Request for Class II Permissive Change

Regarding: *FCC ID: ZMOFG132NA*

Date: 2024/08/30

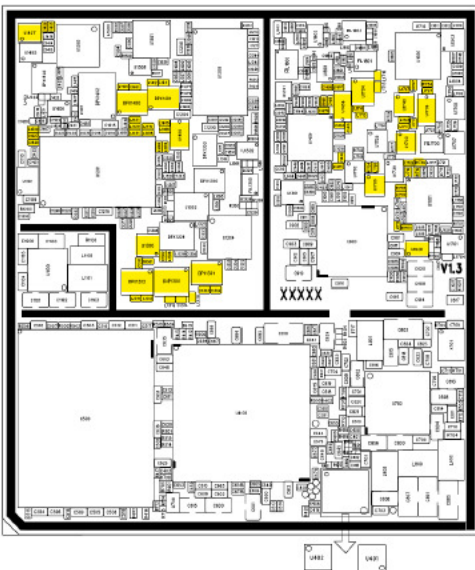
1. The Hardware difference: FG132-NA removes non-FCC frequency bands hardware. Removing non-FCC band hardware has no impact on FCC band RF performance. The other hardware is the same.
2. FG132-NA support band: LTE: B2/4/5/7/12/13/14/17/25/26/30/38/41/42/43/48/66/71.
5G NR SA: n2/5/7/12/13/14/25/26/30/38/41/48/66/70/71/77/78

FG132-NA only removes components marked with yellow tags:
